# Appendix I

## Design Review Comments

## Montario Quarter | Shenton Park

### Pre-Lodgement Meeting Report

Figure 12 Building Edge and Street Interface

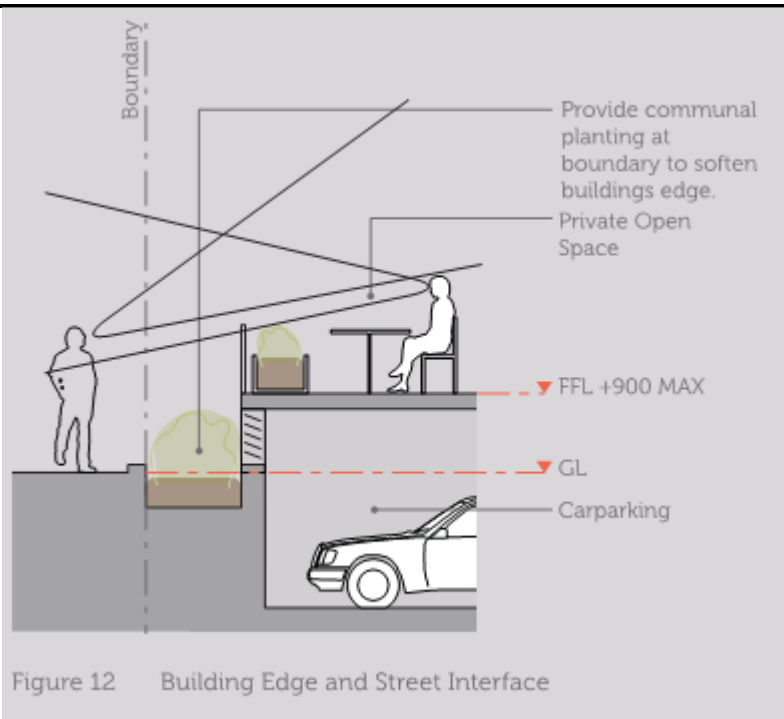
More detail required for Seymour and Selby Street conditions, including corner.

Avoid the use of continuous lengths of blank walls on sites where outdoor space (private or communal) is raised over 0.5m above street level (or open space) by placing planting to soften the edges and reduce their apparent scale.
